M1 Junction 9 Initial Road Safety Assessment

Hertfordshire County Council

17 June 2025

A. Proposed 1 mile gantry may obstruct visibility to existing (blank) sign

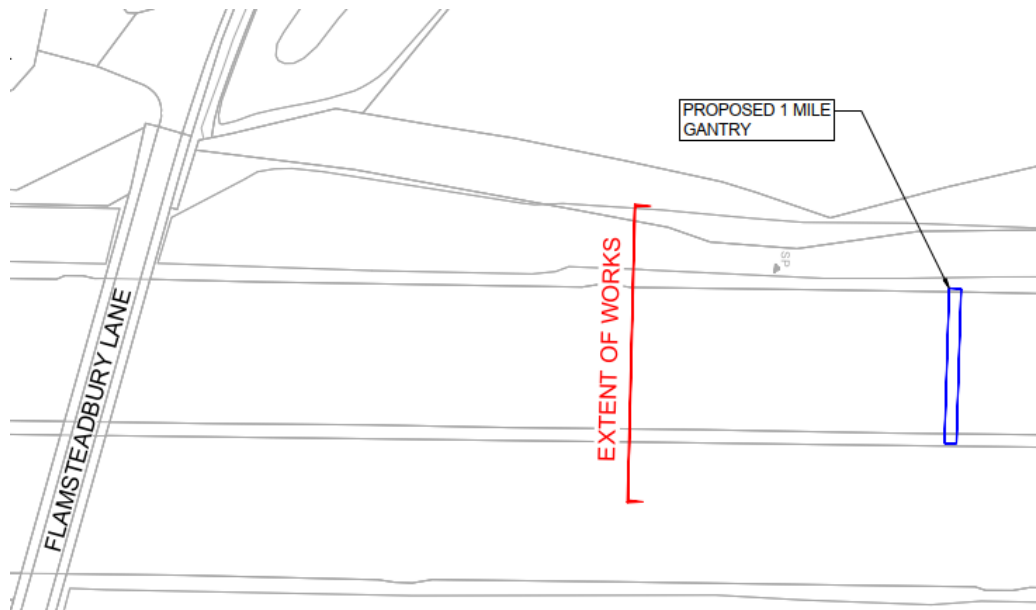
There is an existing sign (which is currently blank) close to the location the proposed 1 mile gantry. Assuming that information is provided on the sign in the future, the relocated nearside gantry leg may obstruct drivers visibility to the sign.

It is recommended that the gantry is not located in front of this sign. It is also recommended that this sign is removed if no longer required.

B. Relocated count down markers may no longer be protected by the Vehicle Restraint System (VRS)

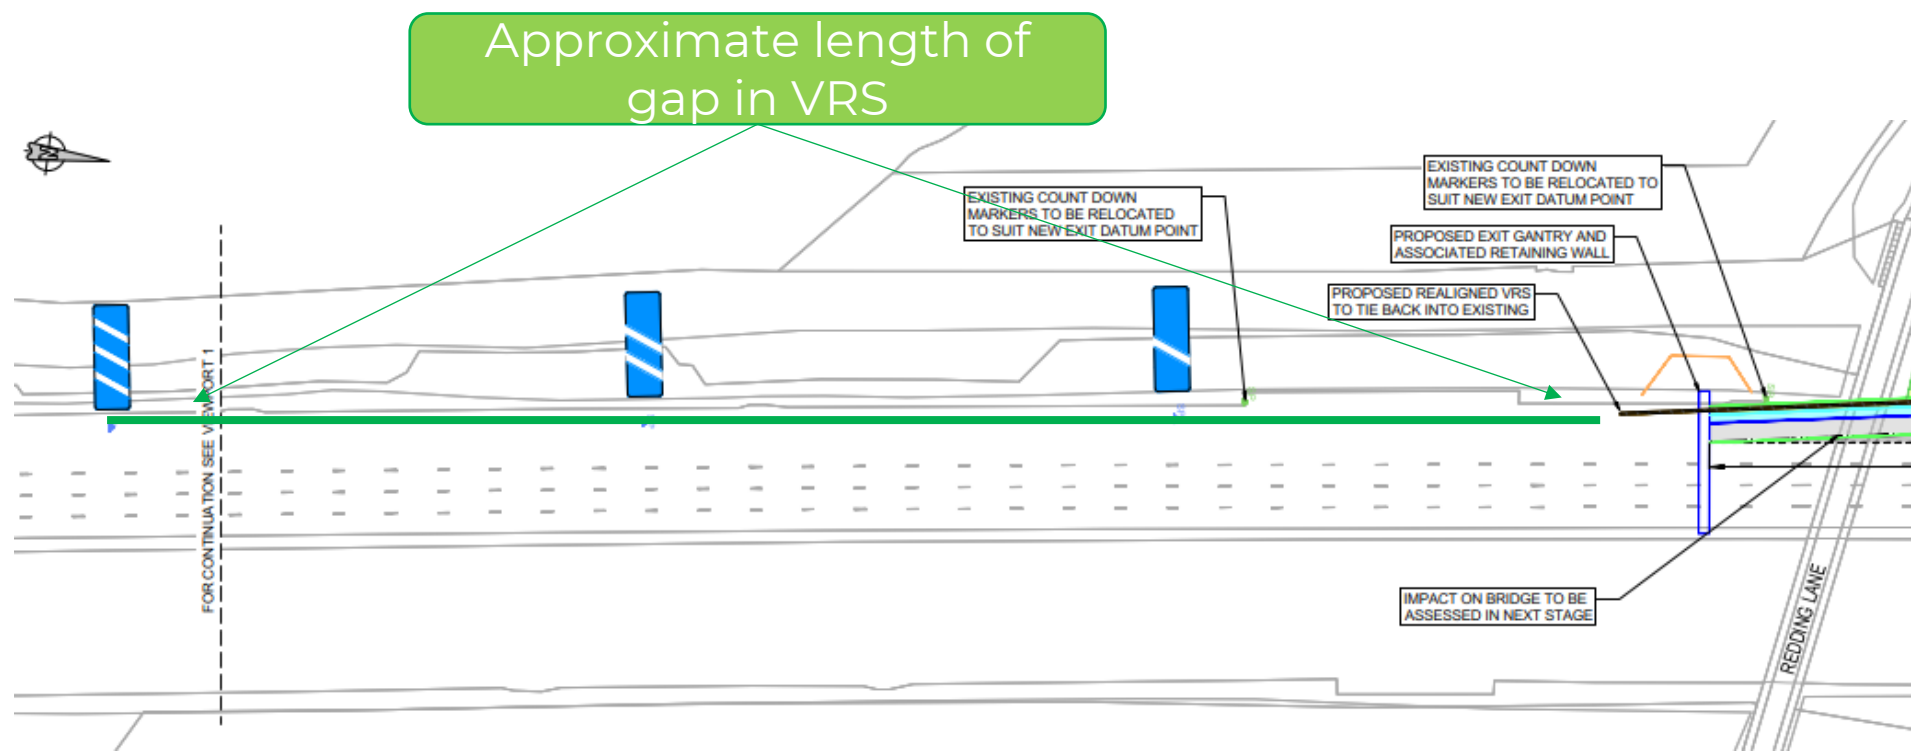
The majority of this section of the M1 is provided with a Vehicle Restraint System (VRS) on the nearside. However, there is a gap in the VRS which begins after the existing 1/3 mile gantry, and starts again after the existing 300 yard countdown marker sign. VRS is not shown on the plans except for at the tie in at the diverge, so it is difficult to see its exact location. Currently, only the first of the countdown marker signs is situated within the gap in VRS.

The scheme relocates all three count down marker signs, so that all three might unprotected by the VRS.

Errant vehicles may hit these signs and this may increase the severity of a collision.

It is recommended that additional VRS is provided to remove the gap entirely

C. Existing exit gantry sign may be too late to inform drivers that there are 2 lanes

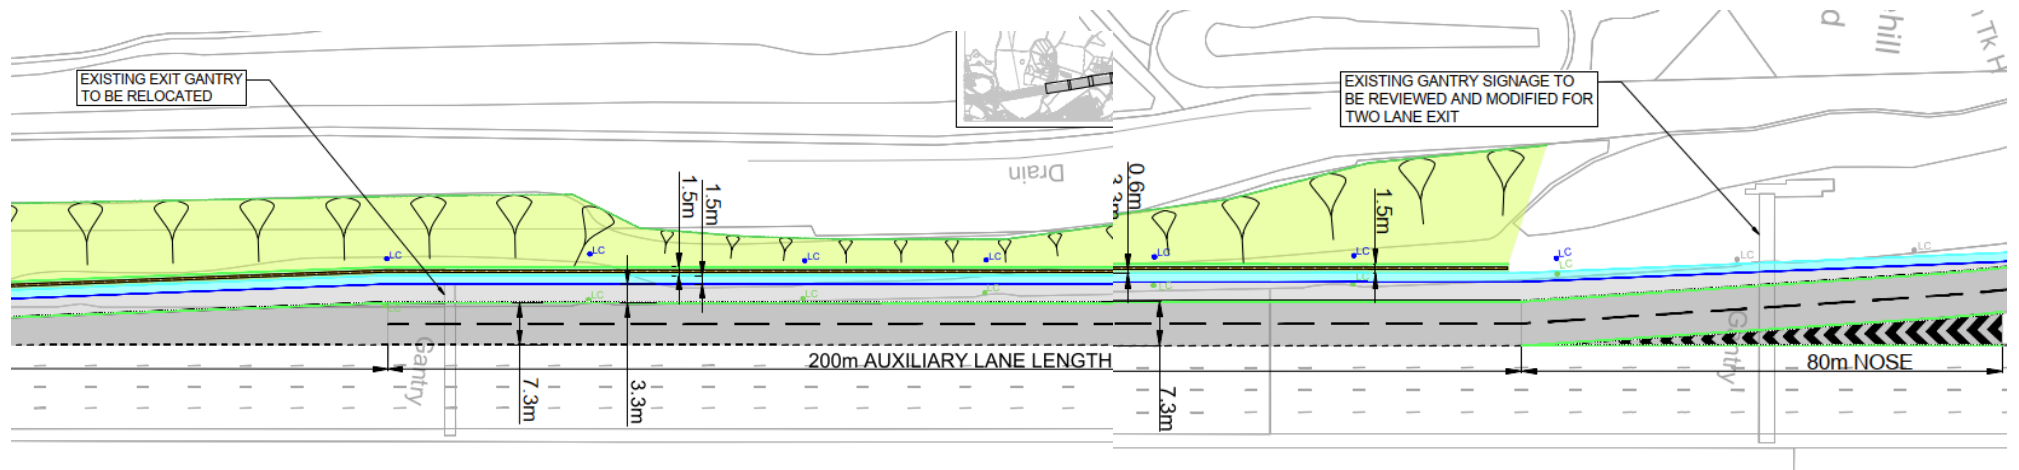
The plans show that the existing gantry sign located as the off-slip deviates away from the mainline will be reviewed and modified to support two lane operation, however it is not proposed to be relocated.

The scheme extends the length of the off-slip and provides two lanes for its duration. The location of the existing exit sign may be too late to provide useful information to drivers to use two lanes.

This may result in late lane manoeuvres and side-swipe collisions.

It is recommended that the gantry sign is be relocated to where drivers begin to use two lanes of traffic, and it should provide information that matches the signs and road markings on the roundabout entry.

D. Visibility around the bend may be reduced due to the widening and change to two lanes

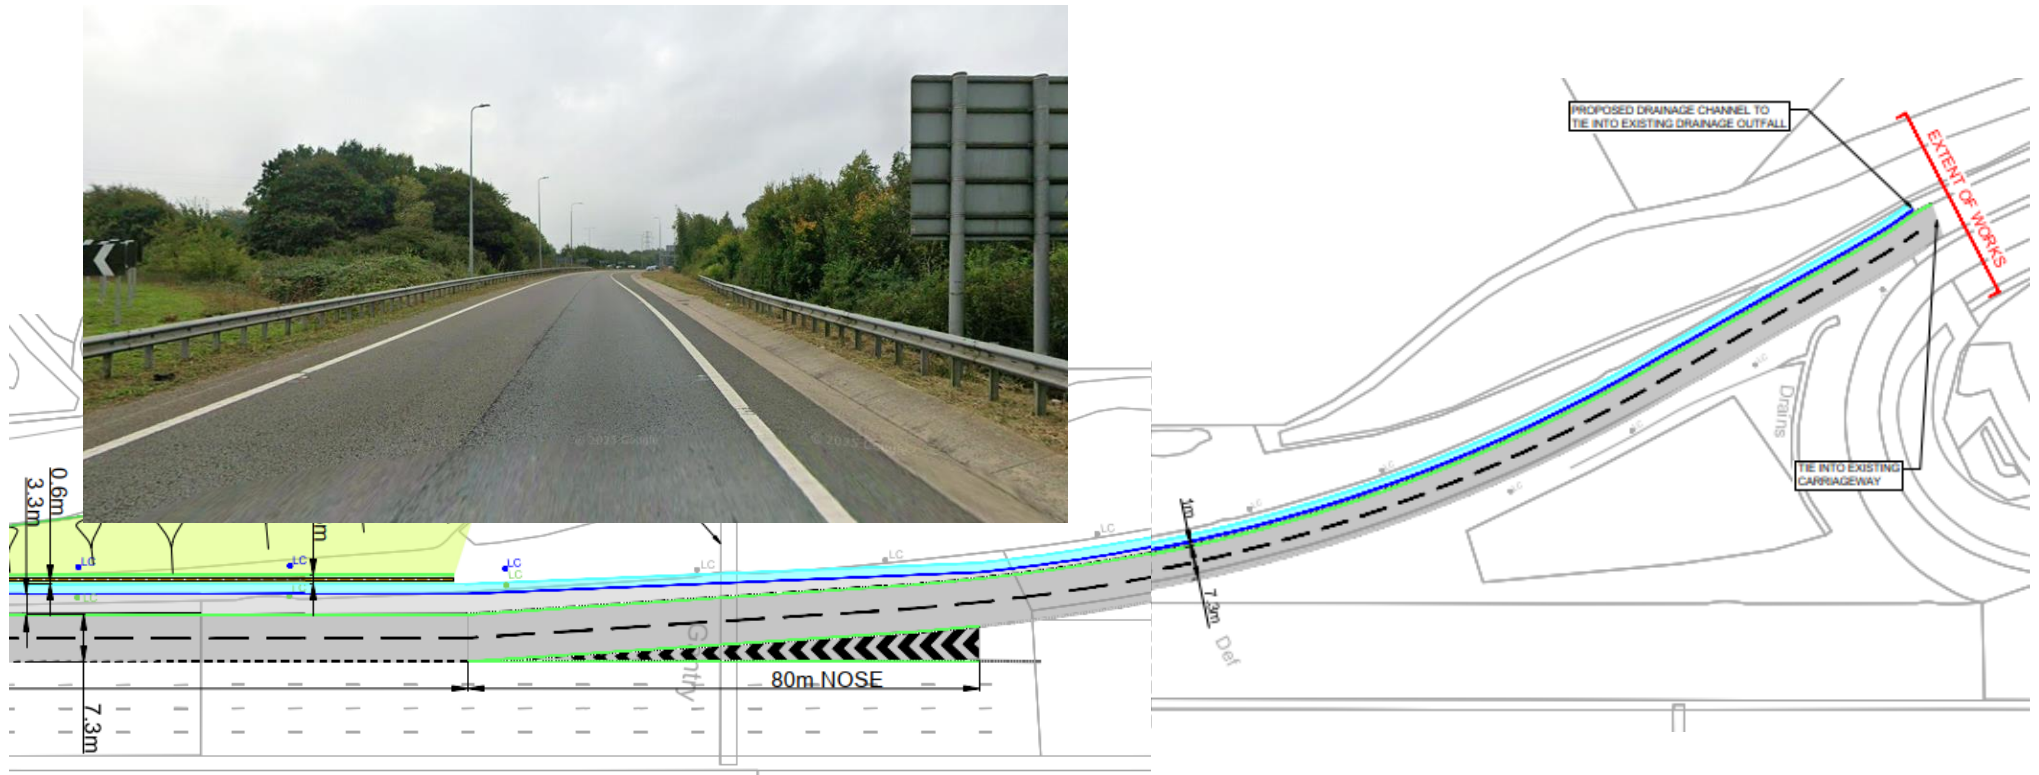
There is an existing left-hand bend within the off-slip that drivers navigate on the approach to the roundabout at junction 9. There is currently an area of land kept clear of vegetation, presumably to maintain adequate forward visibility.

The scheme widens the off-slip and provides two lanes leaving the M1. The drawings do not show any additional areas of vegetation clearance. The changes may result in reduced visibility and drivers may fail to see broken down vehicles, objects in the carriageway or queuing traffic from the approaching junction.

It is recommended that appropriate visibility is maintained throughout the off-slip.

E. Gantry sign leg may be located too close to Vehicle Restraint System (VRS) for it to operate safely

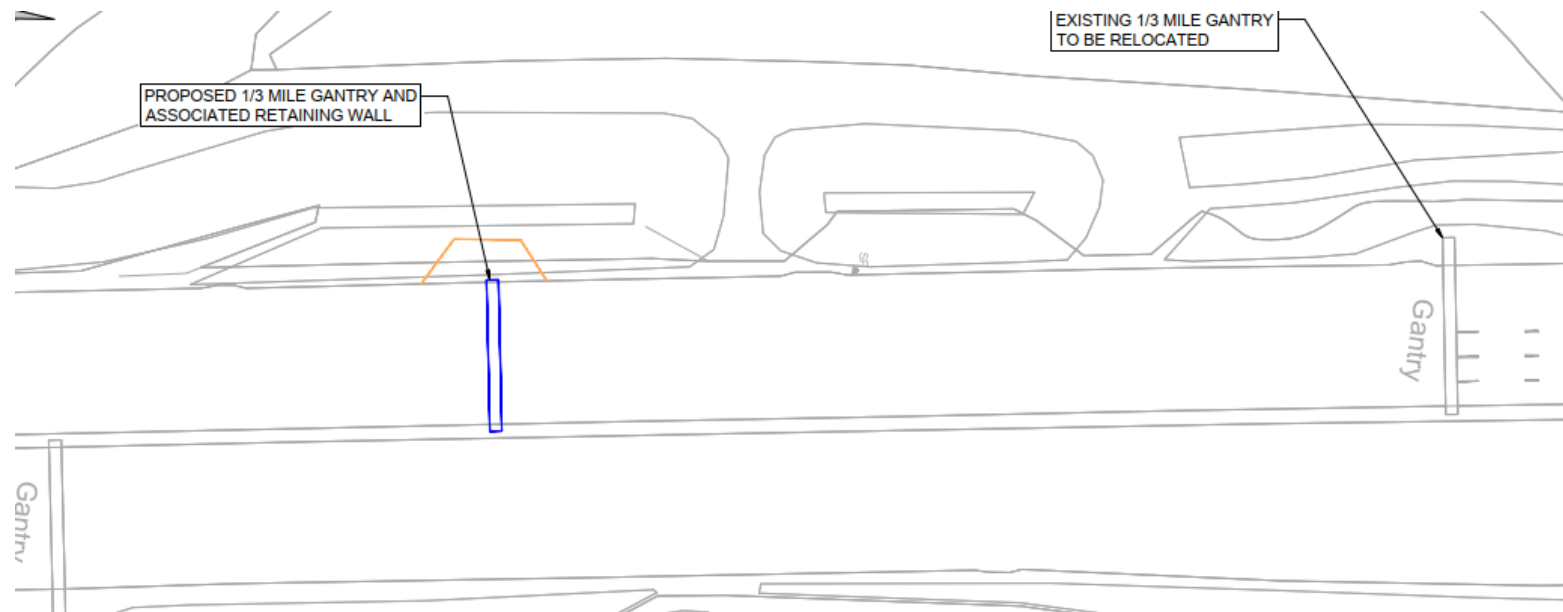
The scheme proposes to relocate gantry signs as part of the off slip extension. The drawings provided do not show the location of all the Vehicle Restraint System (VRS) and the early stage of design means that the information on sign size and location may be more indicative.

However, as shown, some of the gantry sign legs may be located close to the existing VRS. This may result in the VRS failing and increasing the severity of any injuries resulting from errant vehicles hitting the VRS.

It is recommended that all the gantry sign legs are installed an adequate distance behind the VRS

i. Widening the carriageway under bridge may not be feasible given the proximity of the bridge's retaining structure

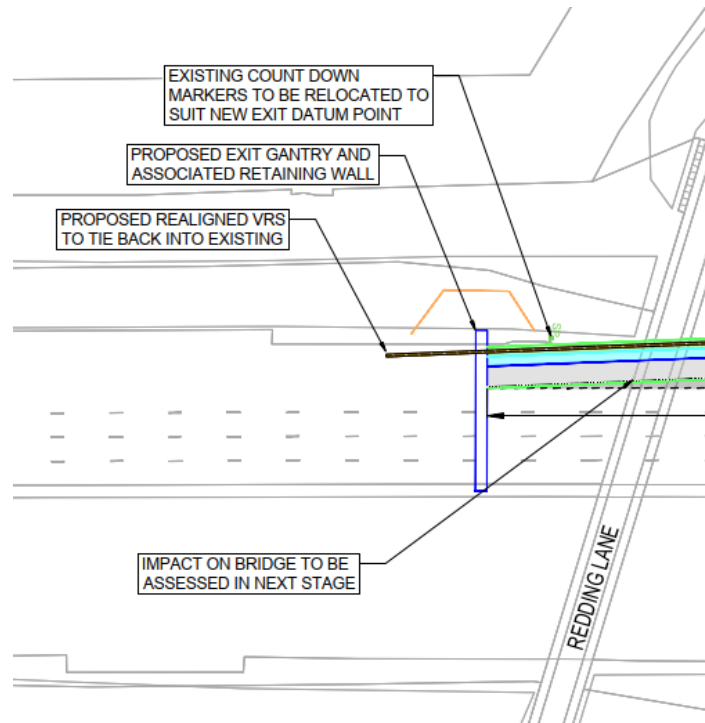
The proposal includes the widening of the road underneath the Redding Lane bridge. The widening is relatively modest, however, there appears to be little space between the edge of the road and the bridge retaining structure.

If the plan is to upgrade the retaining structure (and increasing the gradient) to provide additional road-space, then the widening can be accommodated.

However, if there are no plans to adjust the retaining structure, then there may not be enough space to facilitate the road widening. This may result in narrower lanes or a shorter length of exit taper at this location – which may increase the likelihood of collisions.

It is recommended that this area is reviewed prior to the next phase of design to ensure that current assumptions are workable.
